EPC STORMWATER REVIEW COMMENTS IN ORANGE BOXES WITH BLACK TEXT

Stormwater Detention and Infiltration Design Data Sheet

Stormwater Facility Name: Pond A2

Facility Location & Jurisdiction: Overlook Filing No. 1- El Paso County

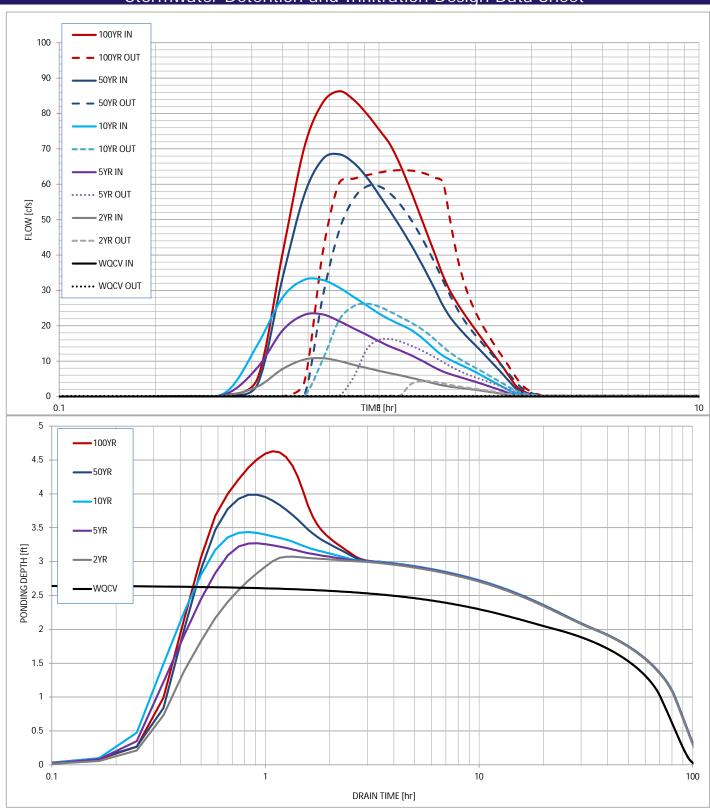
These don't match the MHFD spreadsheet in

the drainage report.

These drain times are signficantly different than what is reported in the drainage report. See comments there

THE MHFD DETENTION SPREADSHEETS
OVERRIDE THE WQCV TO INCLUDE ONLY THE
AREAS OF THE ROADWAYS, AS THE OTHER
PORTIONS ARE EXEMPT. THERE IS NO WAY TO
OVERRIDE SDI SPREADSHEET WITH THE
MANUAL WQCV. THIS RESULTS IN VERY
DIFFERENT RESULTS. THE ONLY WAY TO GET
THE SDI TO SHOW SIMILAR VALUES WOULD BE
TO MANAULLY MANIPULATE THE WATERSHED
AREA AND OTHER FACTORS TO GET CLOSER
TO THE ACTUAL WQCV.
